FOUNDATION LUTHERAN CHURCH

SITE DEVELOPMENT PLAN

V2_Site Development Plan Comments.pdf Markup Summary

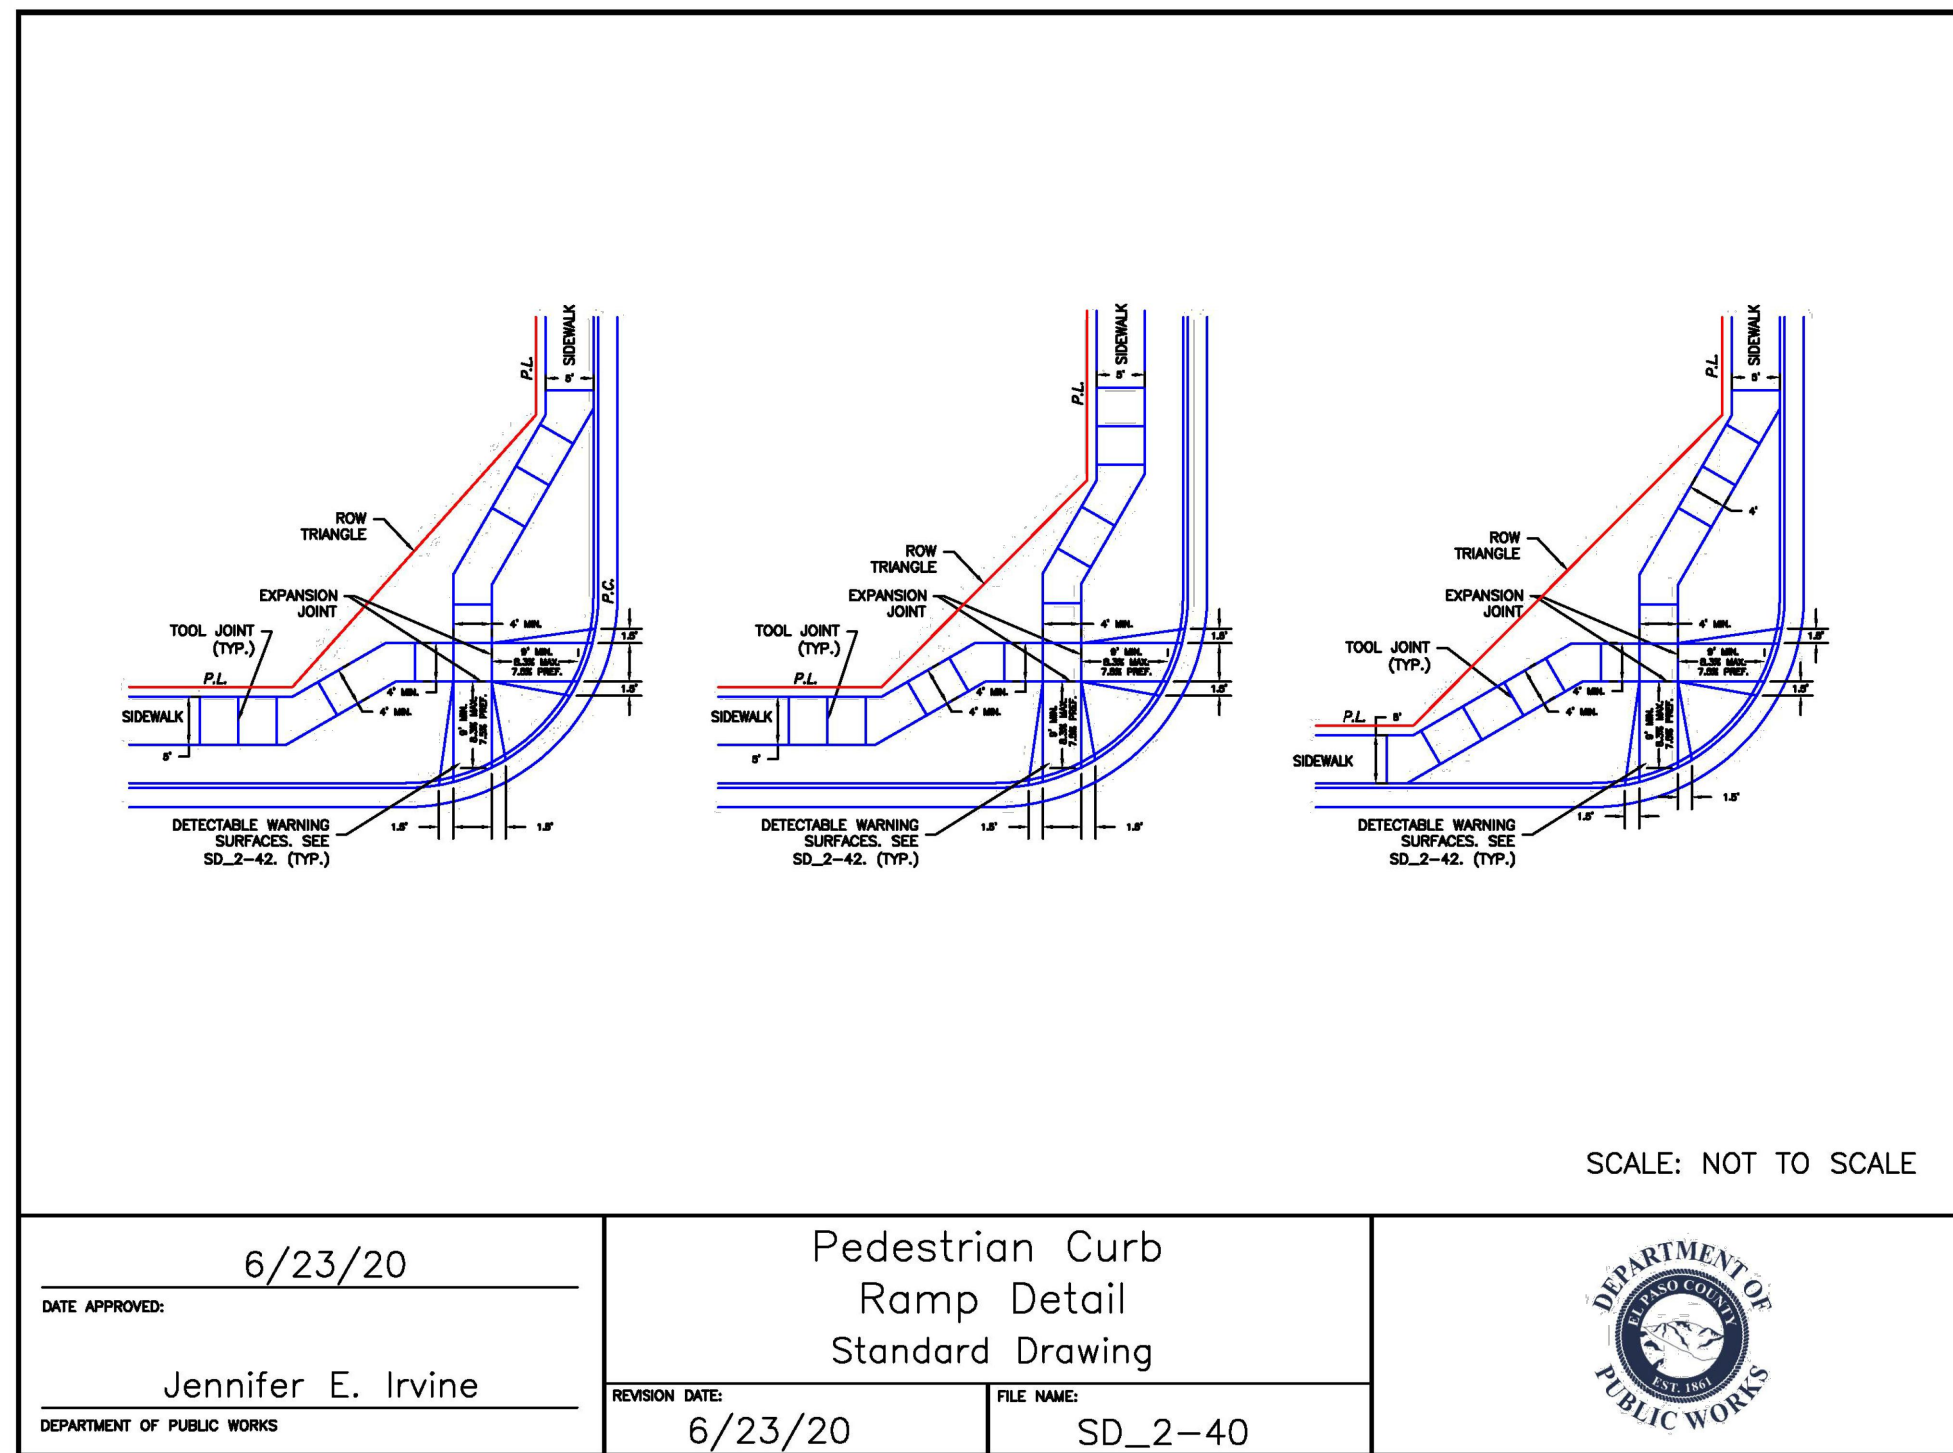
Previous review comment showed receiving ramp at this location, however please show receiving pedestrian ramp at this location across existing ramp.

Remove ped ramps.

Please see comments on GEC Plan regarding driveway access. Minimum curb return radius shall be 25'. Width does not include curb return radius.

Move crosswalk markings to here.
